# 1968 Corvette: Service News: Tune-up Specification Change

**Subject:** Tune-up Specification Change

**Model and Year:** 1968 Corvette with 427 cu. in. Engine, Manual Transmission and Air Conditioning

**Date:** February 1968, Volume 40, Issue #2

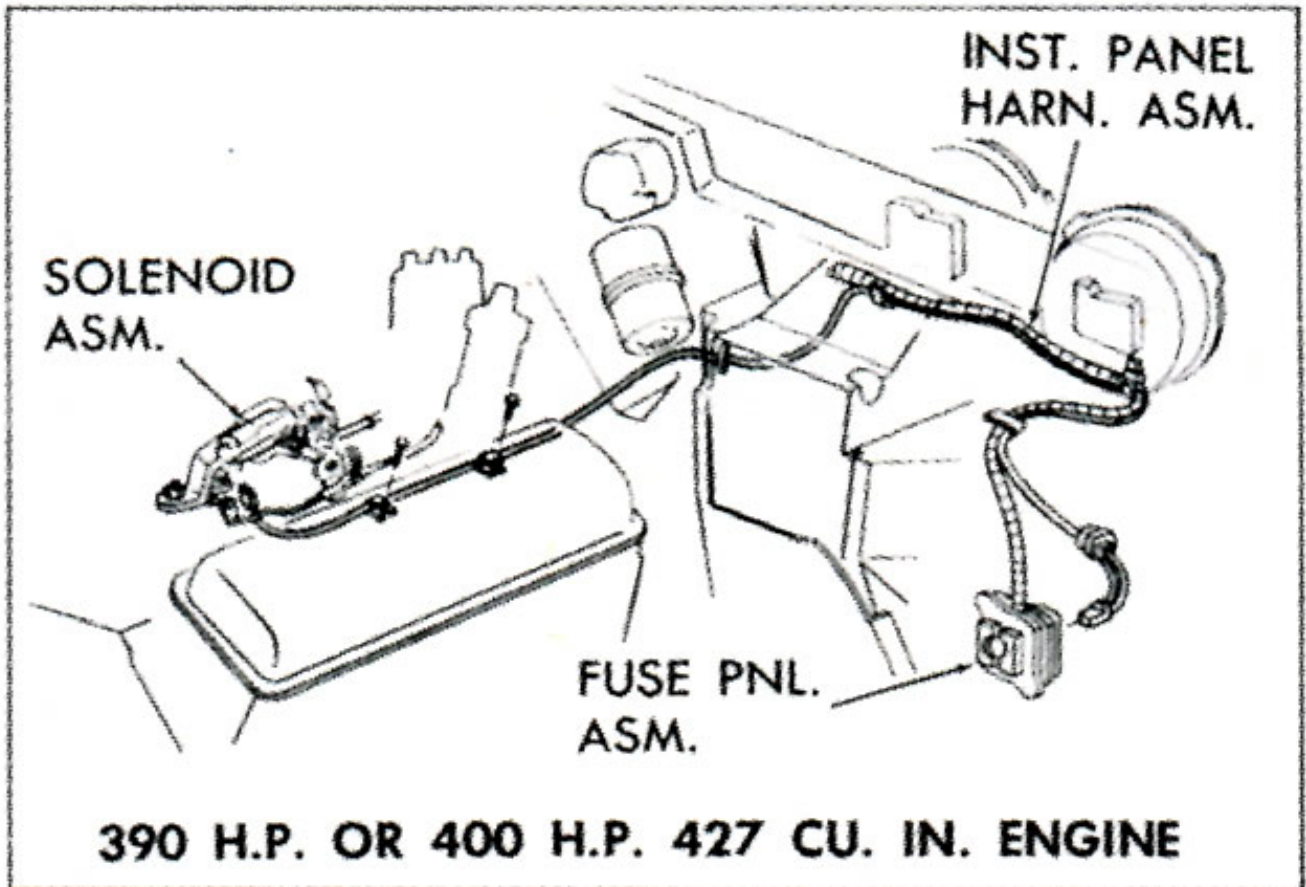
If the anti-dieseling solenoid on one of these vehicles requires replacement or adjustment, refer to the procedures given on Page 7 of this Service News issue. The 'Anti-Dieseling Solenoid Diagnosis Chart' on Page 7 of this issue should be of assistance in determining whether replacement is necessary. Figure 6 illustrates proper solenoid wire routing for either the 390 or 400 H.P. engine. The connector at the use panel should be inserted in the receptacle marked "IGN" for proper solenoid operation.

Fig. 7—Anti-Dieseling Solenoid Installation

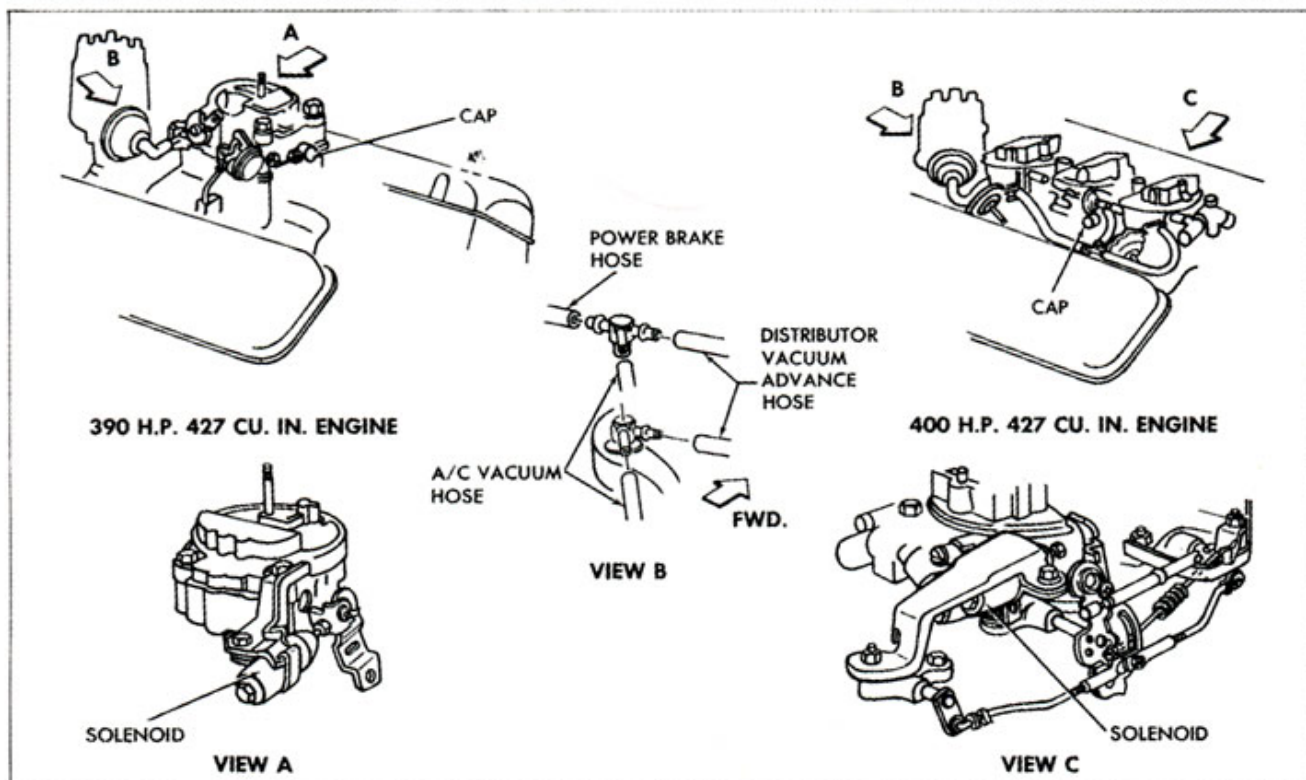
Figure 7 illustrates proper solenoid installation on both the 390 and 400 H.P. versions of the 427 cu. in. engine and also illustrates the correct intake manifold vacuum fittings for the full manifold vacuum distributor advance arrangement.
